## TEMPORARY EROSION CONTROL DETAILS

**STANDARD**

**T-1**

**CORRECTIONS & REVISIONS**

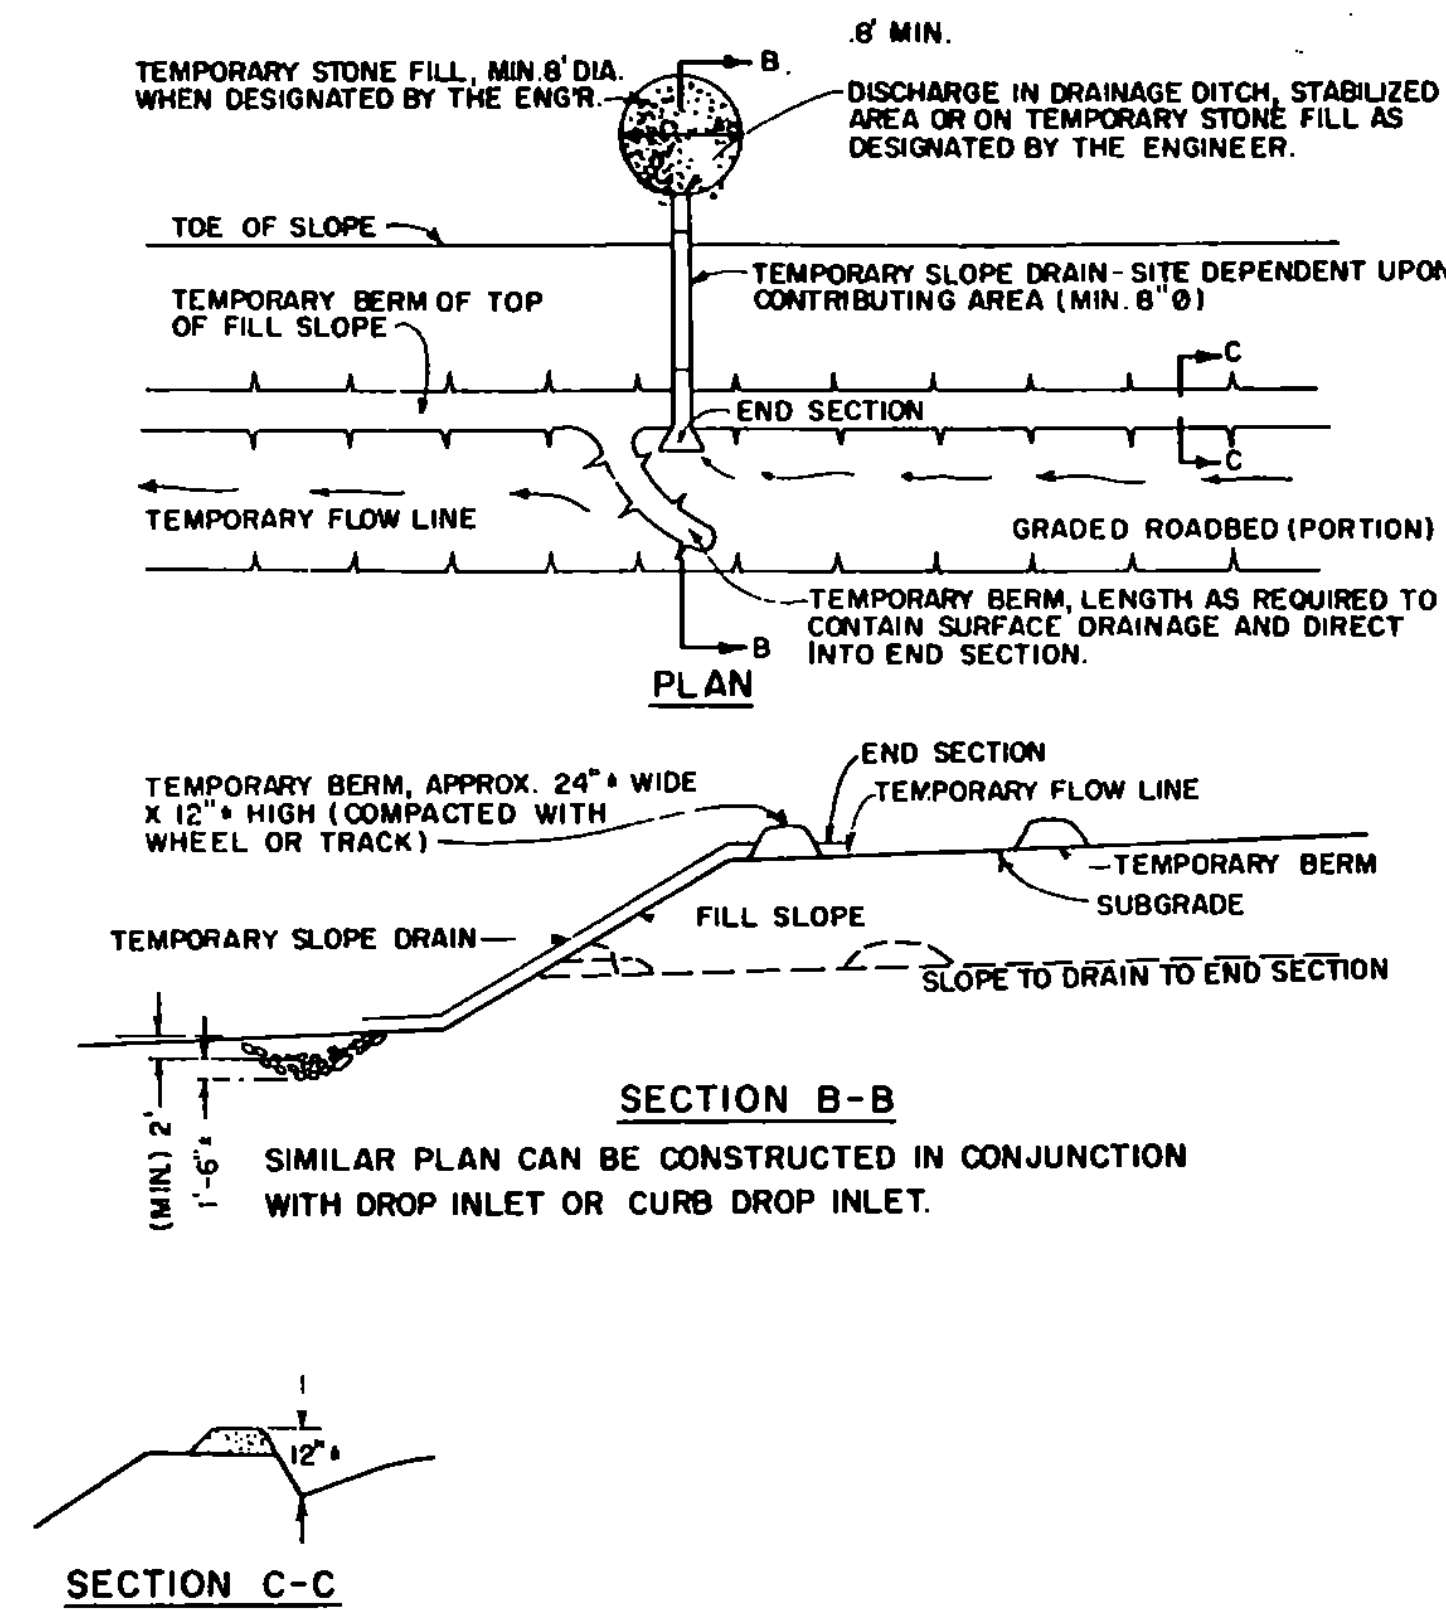
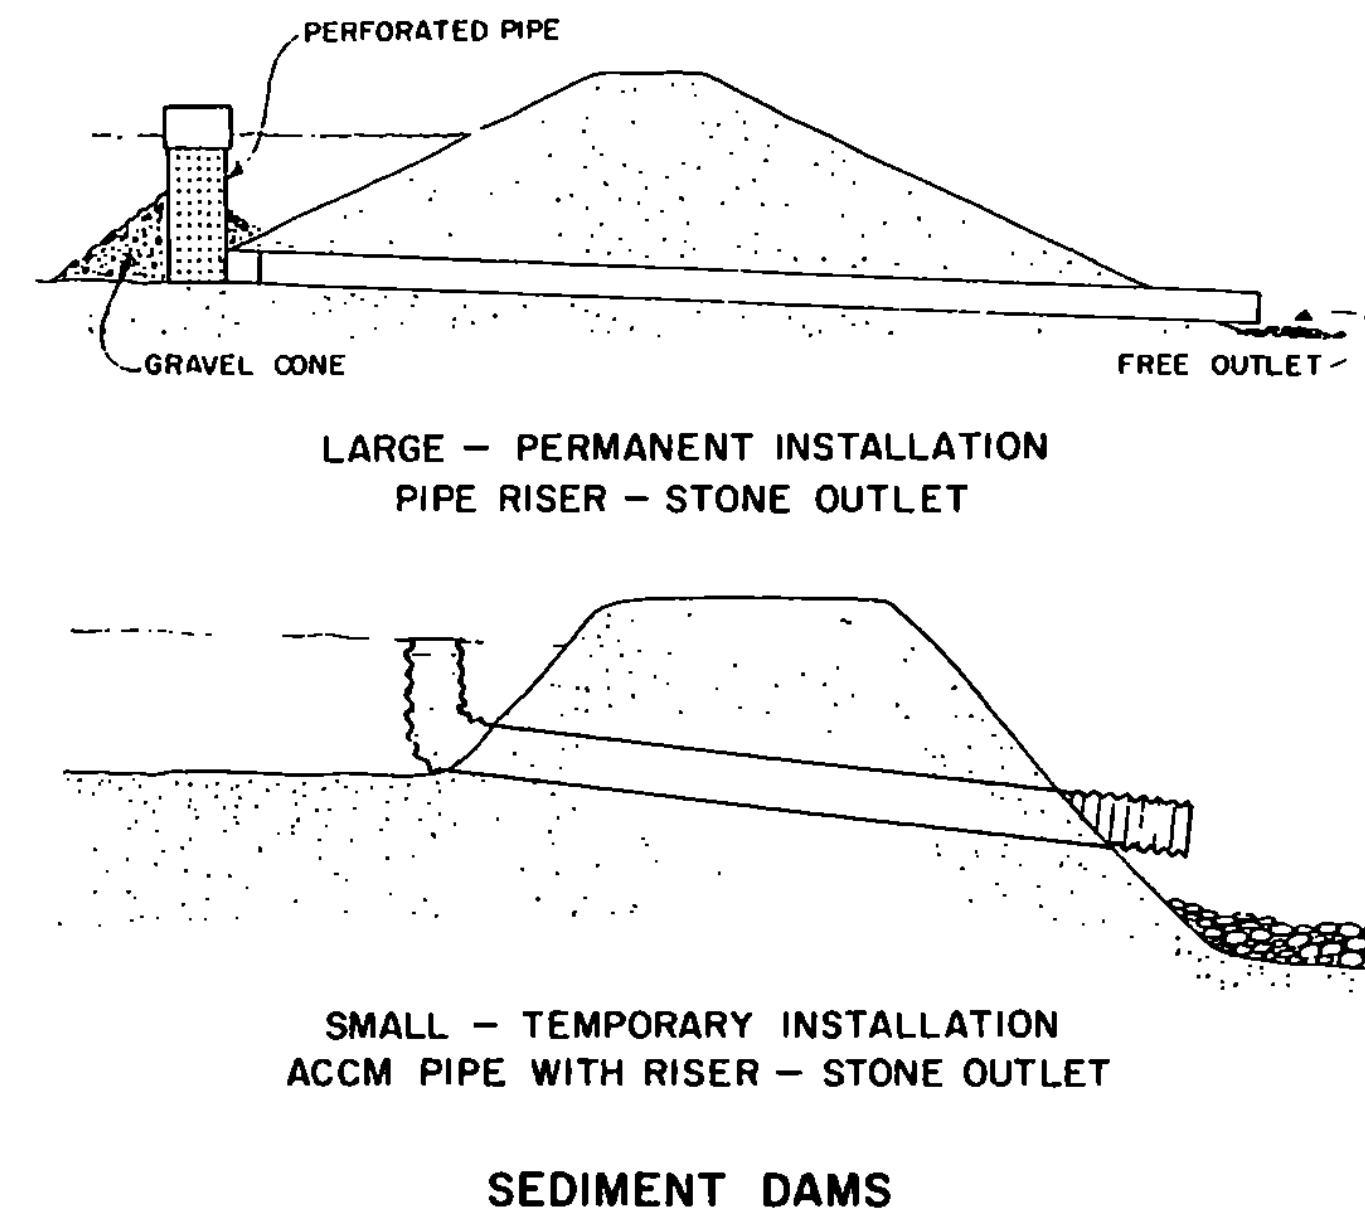
JUNE 14, 1973 - SEDIMENT TRAPS REMOVED FROM TEMPORARY  
BERMS AND SLOPE DRAINS FOR FILL SLOPES.

FEB. 26, 1976 - SILT FENCE ADDED.

DEC. 7, 1976 - HAY BALE ANCHOR NOTE ADDED.
